ZAO-INCORPORATED
THEATER

A-8
CARRIAGE HOUSE
DETAILS &
LANDSCAPE PLAN
MARCH 12, 2004

A-1
WINDOVS
WINDOVS & L

WINDOW TYPE

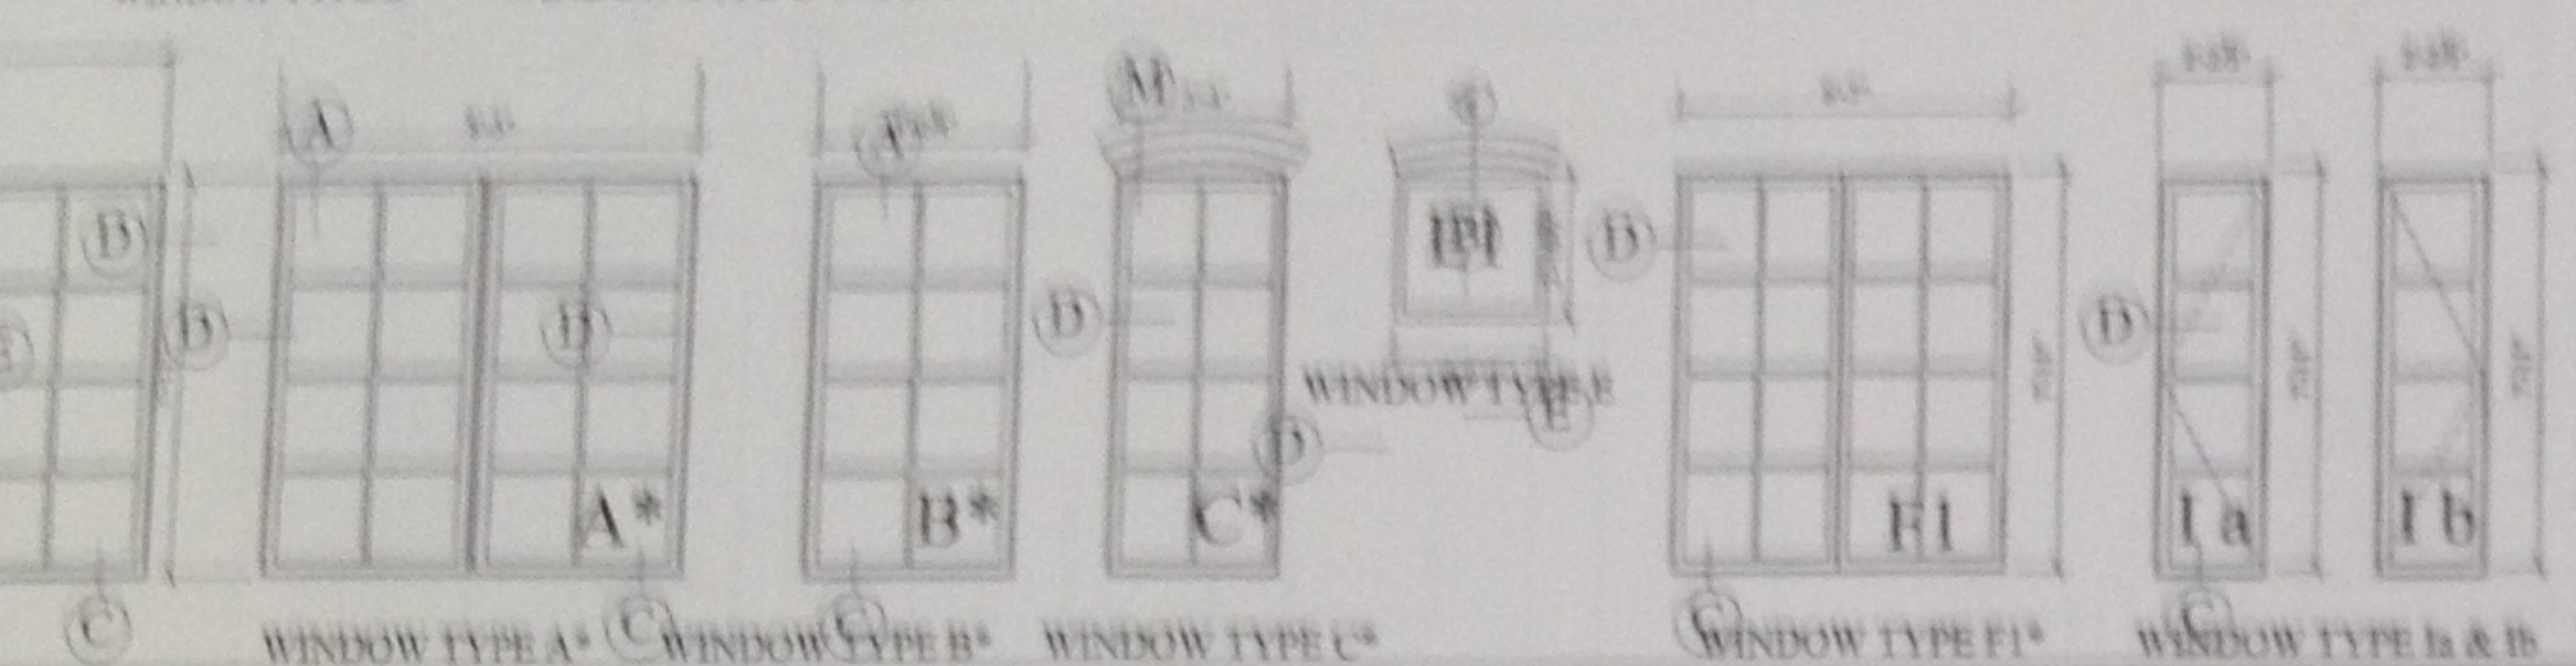
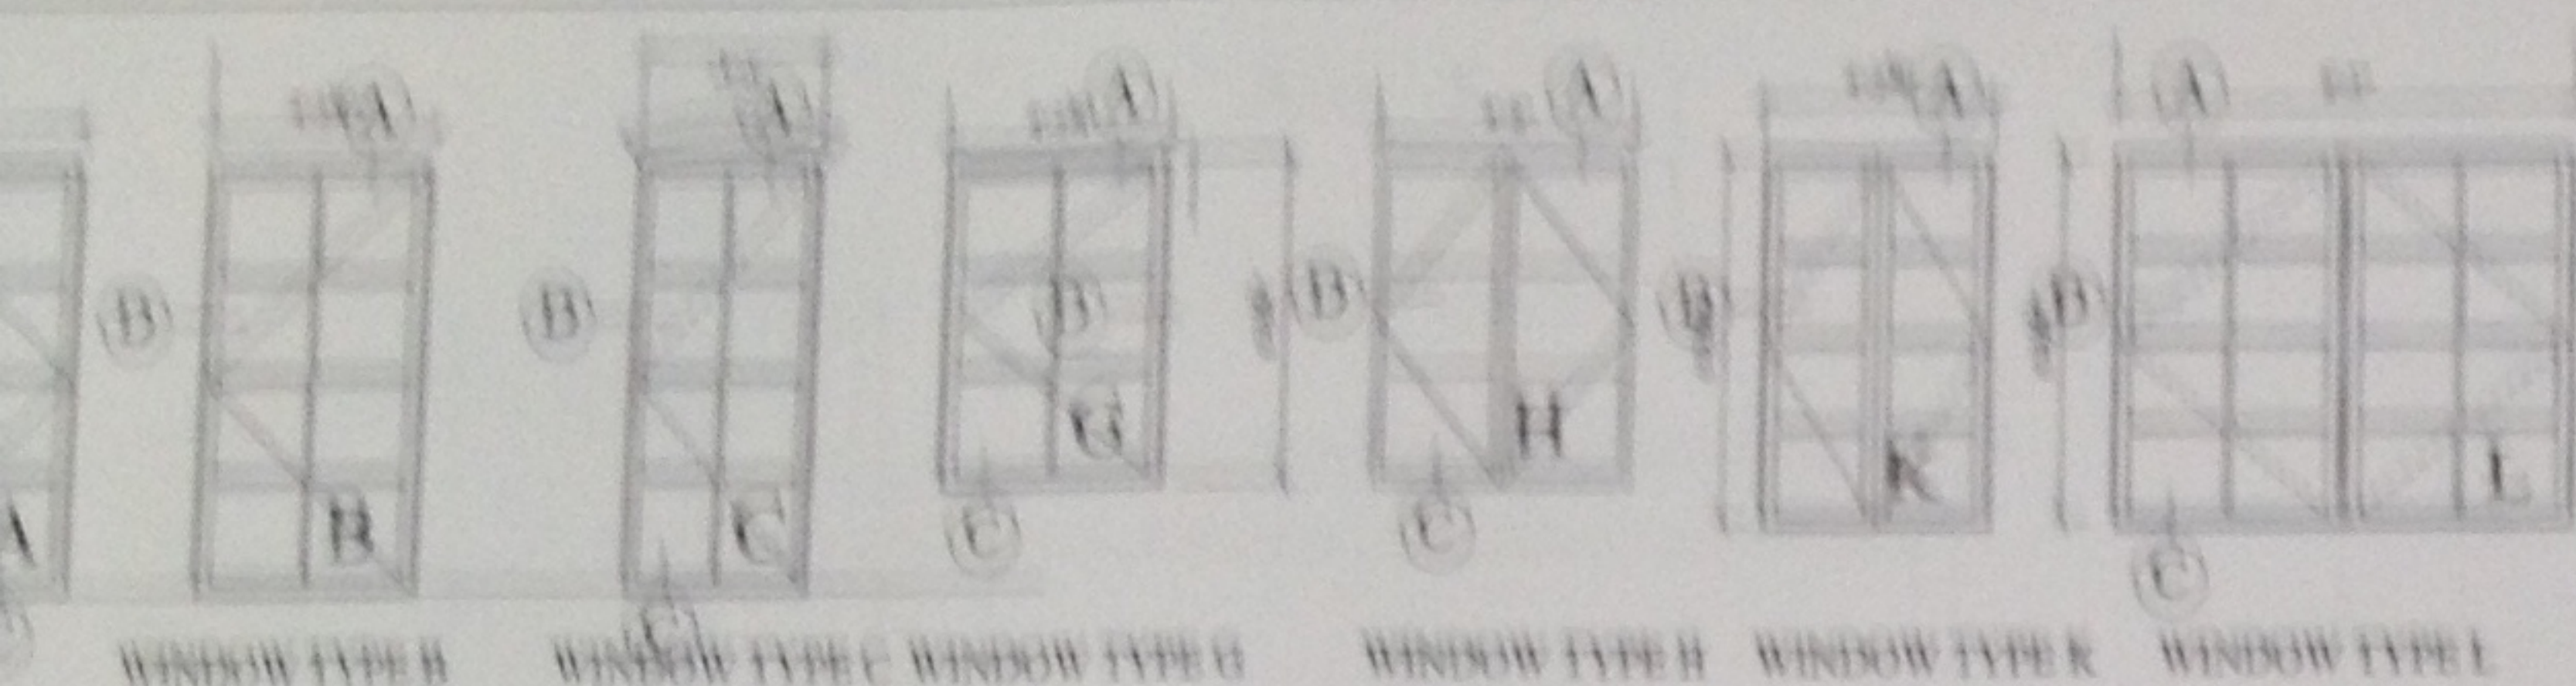
ALL WINDOWS TO BE WOOD
W2 AND W1 TO EDGE OF NICHES IN EXISTING
FACADE - DETAIL TO BE REVIEWED BY STAFF
UPON REMOVAL OF PERMA STONE
